# IFSAR Quality Assessment Report

## AK\_MidAccuracy-DEM6-Lot3\_2013

NGTOC

2014-08-08

Checkpoint Distribution Image

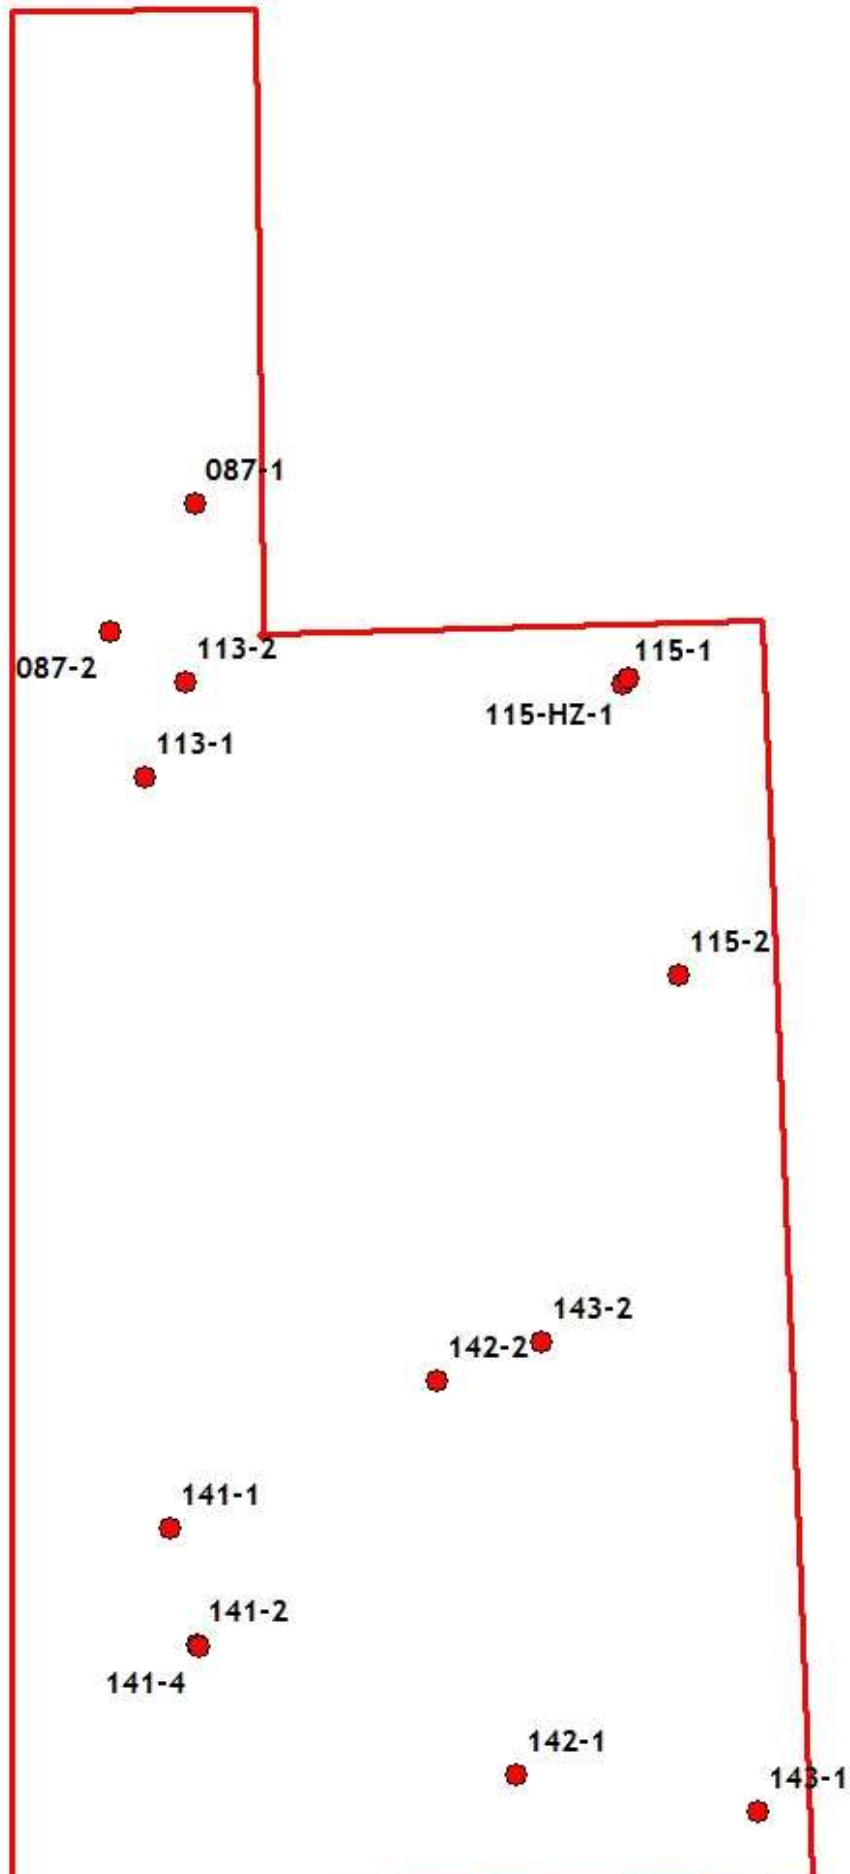
Checkpoints are well distributed?

Enough checkpoints for task order?

Enough checkpoints for NED?

Vertical Accuracy Results:

Based on this review, the USGS accepts the vertical accuracy.

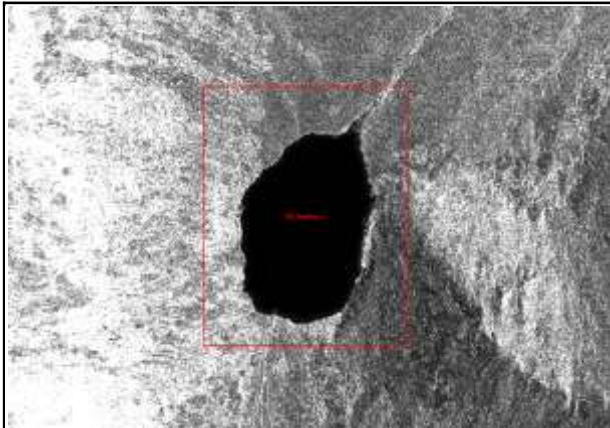
Missing breakline around waterbody in Cell 143

*\*issue has been fixed by vendor, reviewer now accepts the breakline files.*
